SERVICE BULLETIN

INTRODUCTION OF A NEW OIL DIPSTICK

FOR ROTAX® ENGINE TYPE 912 AND 914 (SERIES)

SB-912-040 R1

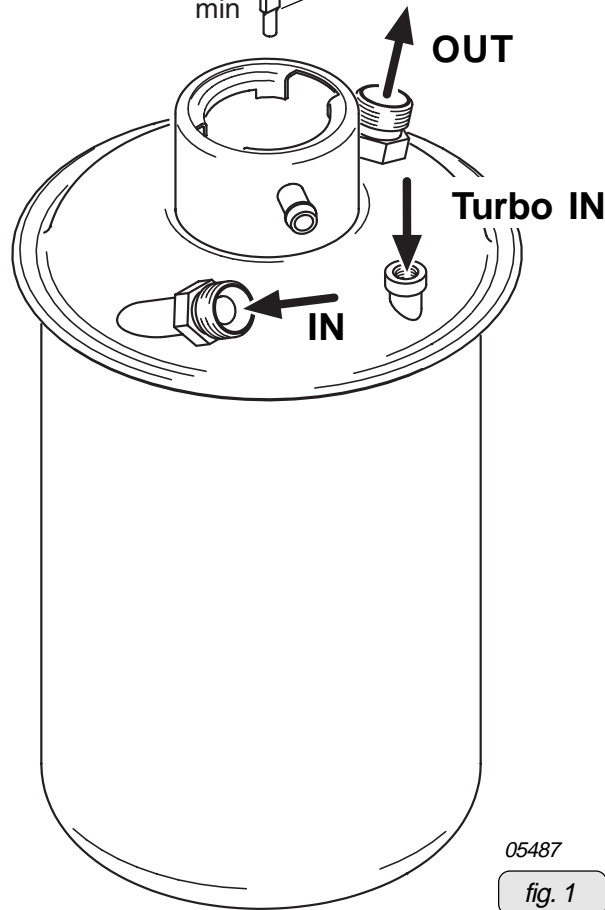
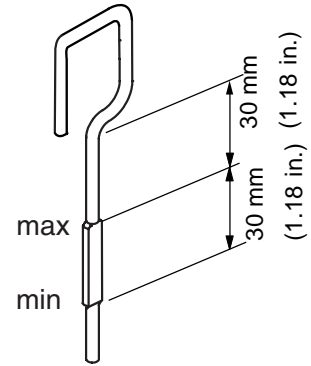
◆ **NOTE:** By changing the oil dipstick, the minimum oil level is raised by approx. 40 mm (1.57 in.) and the height between the "min." and "max." level is reduced to 30 mm (1.18 in.) (approx.0,45 litre).

oil dipstick, old version

oil dipstick, new version

- Remove the oil dipstick part no. 956150 and replace by new oil dipstick part no. 956151.
- Inspect the oil level to be performed SI-27-1997 "Oil level check", current issue.
- Add oil if necessary.
